C S Stokes and Associates Limited

Subject: Grenfell Tower installation of new main gas pipe work.

Gas pipe passing through the staircase to lift lobby area compartment wall, no fire collar has been fitted and the hole has not been made good.

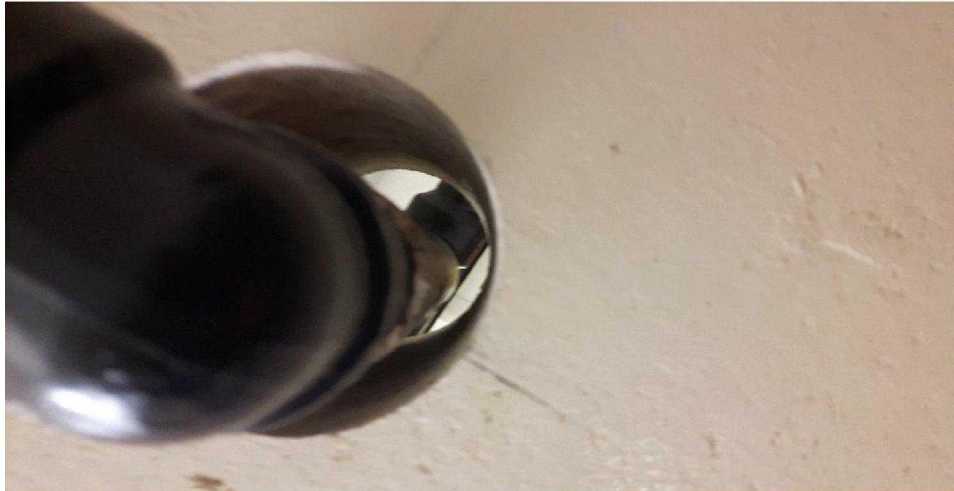
Where the gas pipe penetrates the staircase compartment wall at each floor level there are presently gaps around the pipe, the hole has not been made good. This can be seen in the next 2 photographs.

1. As structural work is being undertaken within this building as part of this project has a Building Regulations application been made for the work/project?
2. All holes in compartment wall must be suitably fire stopped using fire rated materials of a minimum of 90 minutes fire rating.
3. Documentation should be provided by the gas contractor showing the fire rated materials used for the fire stopping of the compartment walls and the fire rating of the fire collars used.
